Table 2 ORC Specific Geotechnical Questions

3.0 Objective

The objective for this geotechnical scope is to perform a technical review on the previous work undertaken associated with the planned extension of the landfill sites design life. As the landfill height increases, the overburden stresses on the underlying ground so to increase. As a result, the stability of the landfill embankments must continue to satisfy the factor of safety requirements for both operation and closure conditions.

Figure 1 Plasticity Chart

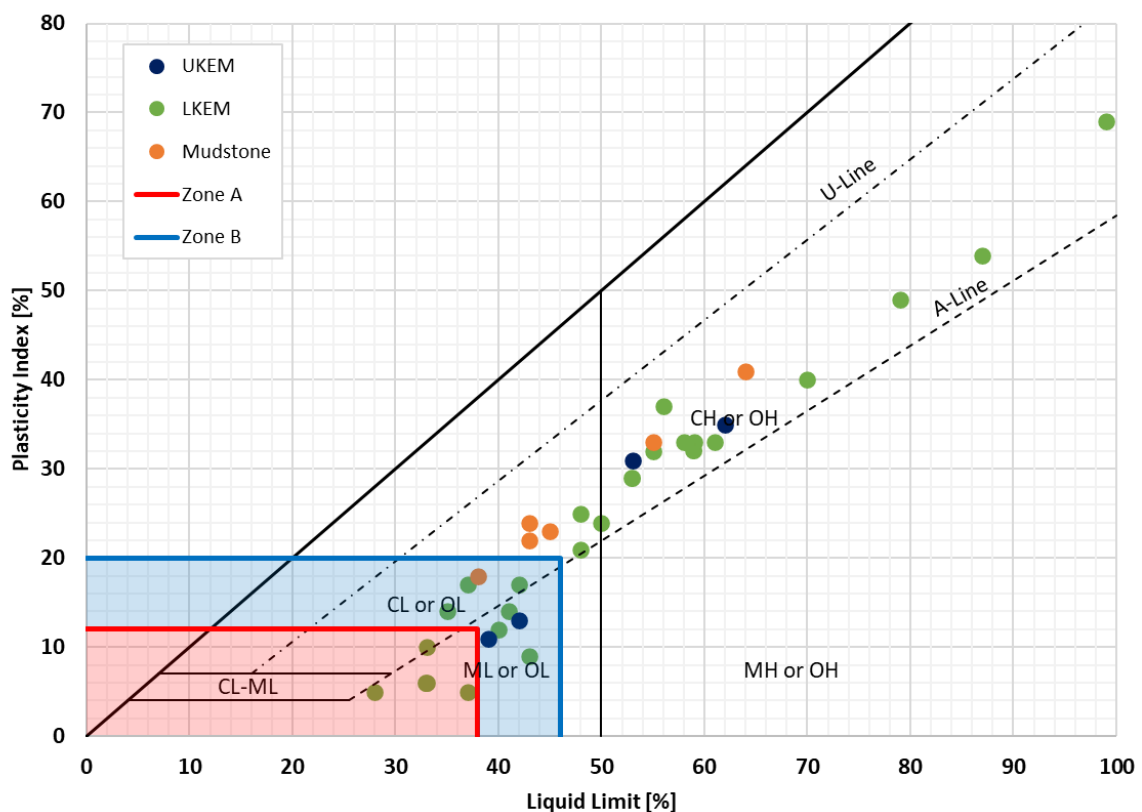
Based on the Seed classification, a number of samples from both the UKEM and LKEM units reflect liquefaction potential (Zone A and B). These samples have a higher level of sand content (sandy clay, sandy silty clay, sandy silt, silty sand).

The UKEM unit is predominantly characterised as generally 'sand like with occasional thin lenses of clay' while LKEM is generally 'clay like with occasional thin lenses of sand'. As a result, it is reasonable to assign the UKEM with a 'High' liquefaction risk, and the LKEM unit with a 'Low' risk.
